IES UTILITIES INC.

December 21, 1994
NG-94-4632

Subject: Duane Arnold Energy Center
Docket No: 50-331
Op. License No: DPR-49
Response to NRC RAI on MSIV Leakage
Control System Technical Specification
Amendment Request (RTS-232)

**IES RESPONSE
TO NRC
REQUEST FOR ADDITIONAL INFORMATION**

| <u>Anchorage Detail</u> | <u>Foster Wheeler Dwg.</u> <u>93-1029-6-101</u> | <u>Bechtel Dwg.</u> <u>7884-C-204</u> |

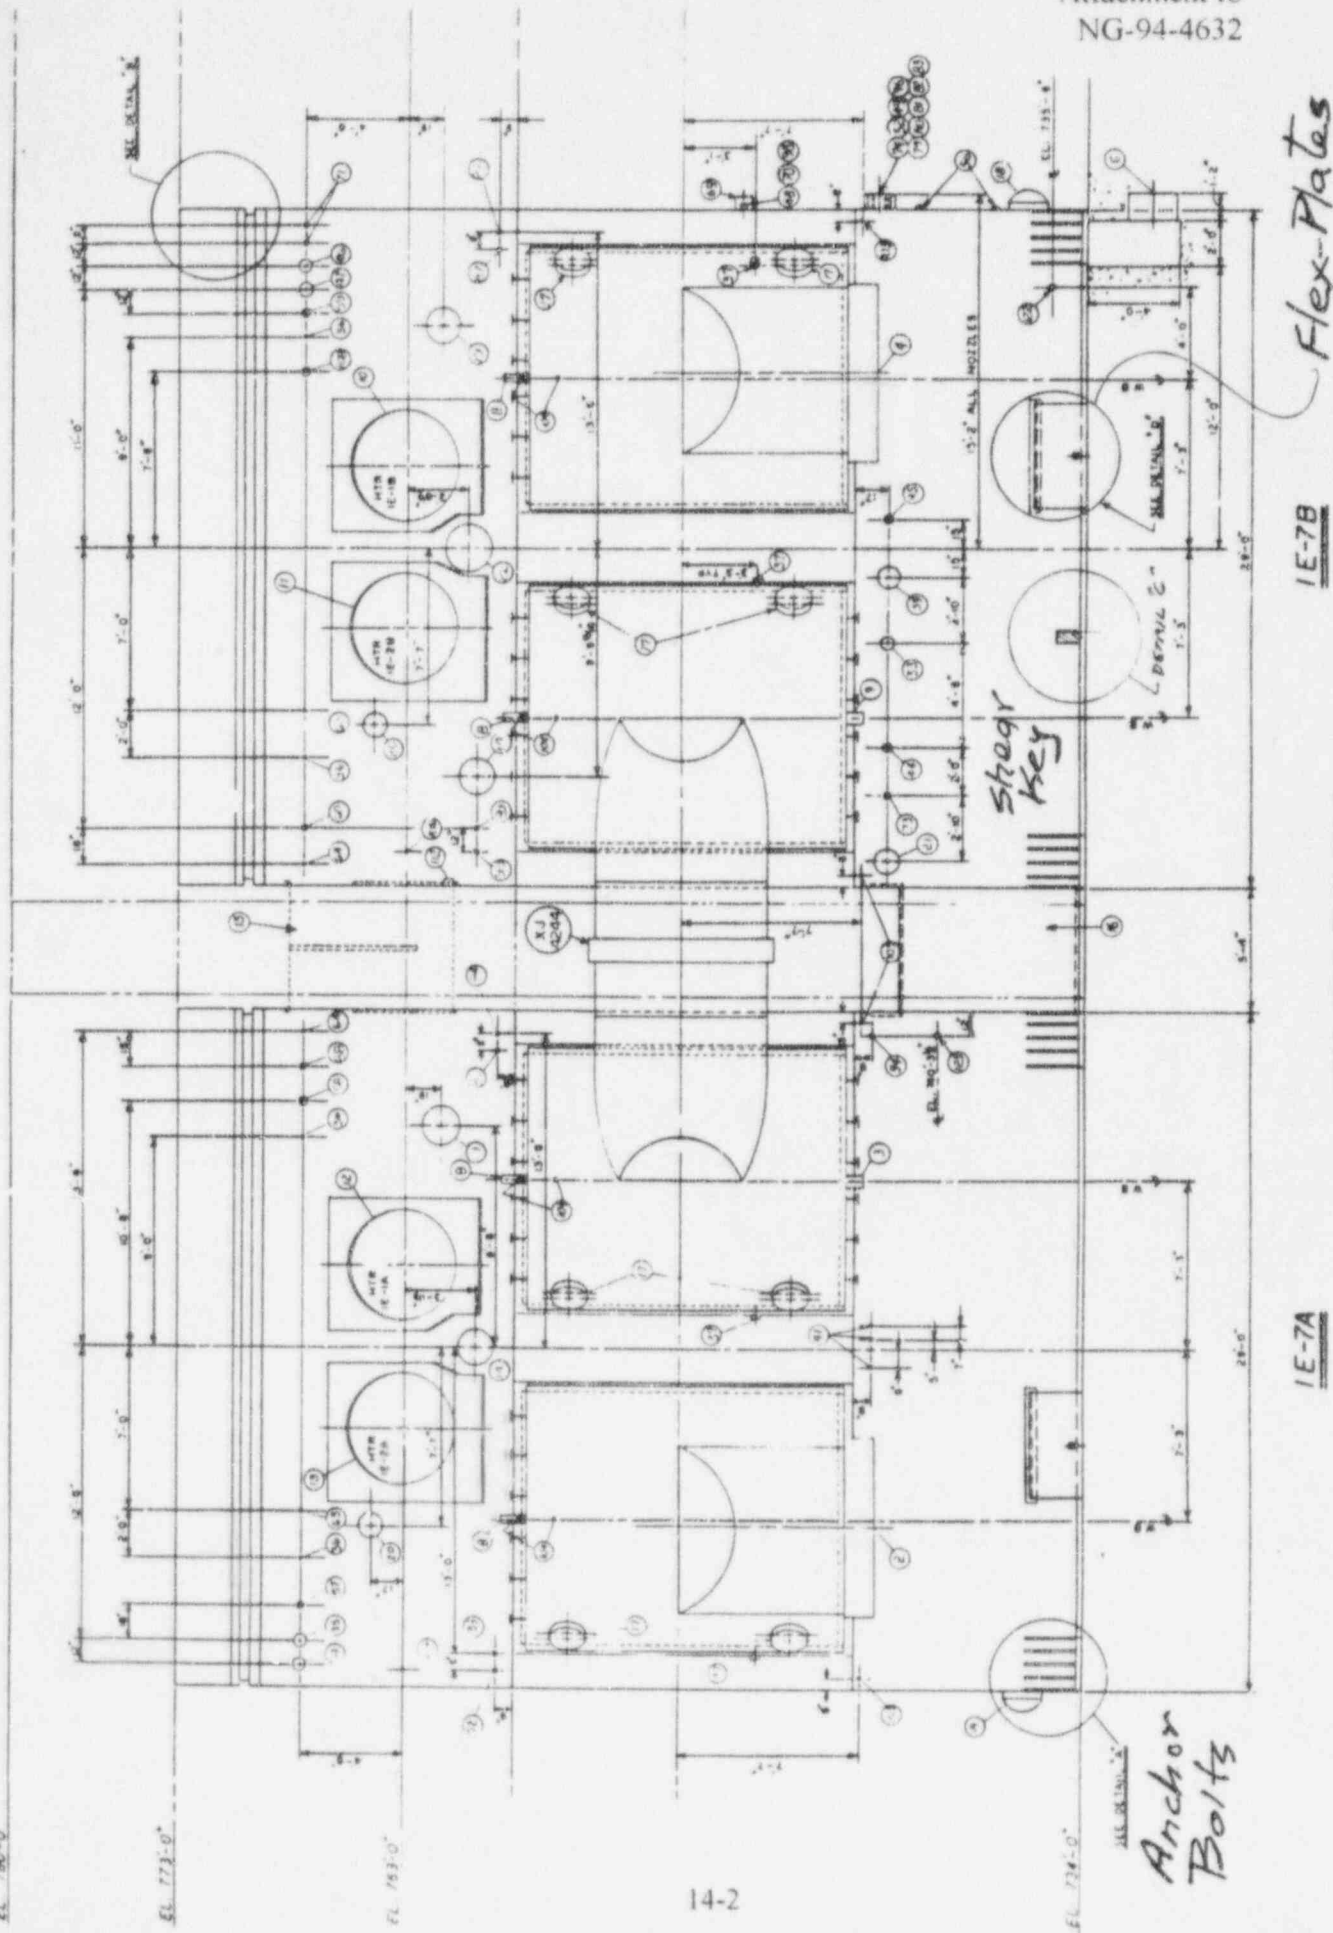
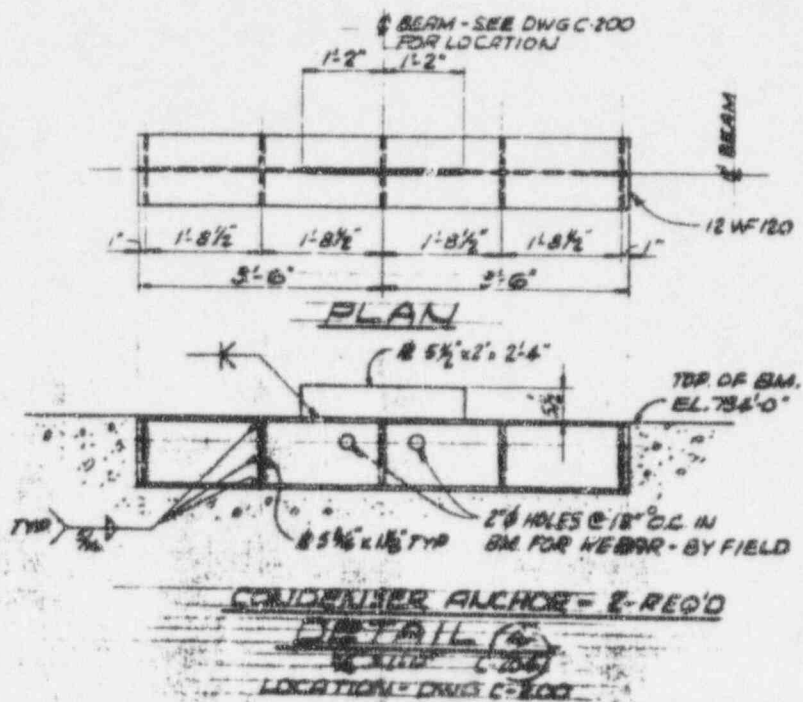
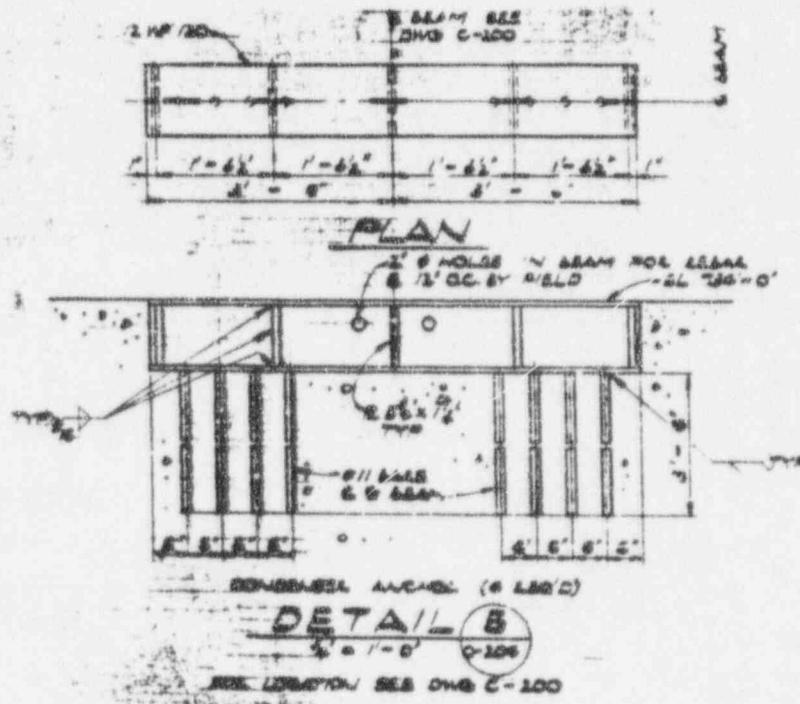
Provide detailed drawings of the shear key and anchor bolts, as well as their anchoring mechanism into concrete of the condenser anchorage system.
